Form 3160-3 (June 2015)					APPROV o. 1004-0 inuary 31,	137
UNITED STATES DEPARTMENT OF THE IN	5. Lease Serial No.					
BUREAU OF LAND MANA	NMNM0438001					
APPLICATION FOR PERMIT TO DF		R REENTER		6. If Indian, Allotee	or Tribe 1	Name
1a. Type of work: Image: Constraint of the second seco	ENTER			7. If Unit or CA Agr	reement, l	Name and No.
1b. Type of Well:	er					
1c. Type of Completion: Hydraulic Fracturing	8. Lease Name and DEEP ELEM 4 FE

2. Name of Operator EOG RESOURCES INCORPORATED				801H 9. API Well No. 30	0-015-	·54775
3a. Address 1 1111 BAGBY SKY LOBBY 2, HOUSTON, TX 77002	le)	10. Field and Pool, of PURPLE SAGE; W	*	•

Eddy County, NM (NAD 83 NME) Deep Elem 4 Fed Com #801H

OPERATOR'S NAME:	EOG RESOURCES INCORPORATED
WELL NAME & NO.:	DEEP ELEM 4 FED COM 801H
SURFACE HOLE FOOTAGE:	554'/S & 1313'/E
BOTTOM HOLE FOOTAGE	230'/S & 660'/E Sec 16 T26S R31E
LOCATION:	Section 4, T.26 S., R.31 E., NMP
COUNTY:	Eddy County, New Mexico

Proposed Wellbore Design A KB: 3,311' GL: 3,286'

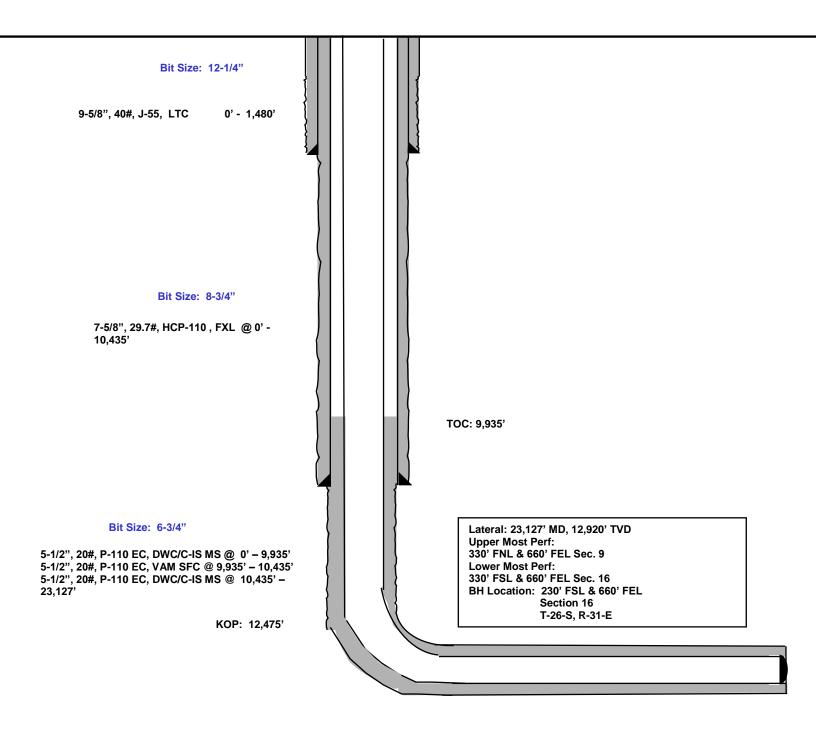
Operator has proposed to pump down 9-5/8" X 7-5/8" annulus after primary cementing stage. <u>Operator must run Echo-meter to verify Cement Slurry/Fluid top in the annulus Or operator shall run a CBL from TD of the 7-5/8" casing to surface after the second stage BH to verify TOC.</u>

- 3. The minimum required fill of cement behind the **5-1/2** inch production casing is:
 - Cement should tie-back at least **200 feet** into previous casing string due to operator not meeting casing clearance requirement per 43 CFR 3170. Operator shall provide method of verification.

554' FSL 1,313' FEL Section 4 T-26-S, R-31-E Proposed Wellbore Design B KB: 3,311' GL: 3,286'

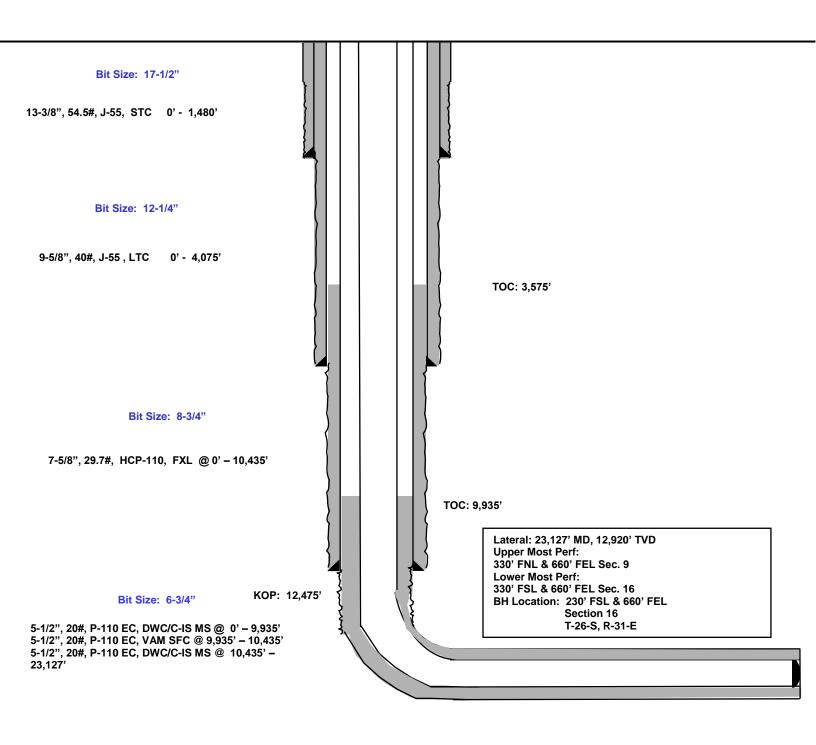
Operator is only approved for Design A. Design B is not to be utilized. If Design B is needed or any other change, please submit a NOI sundry to make the changes.
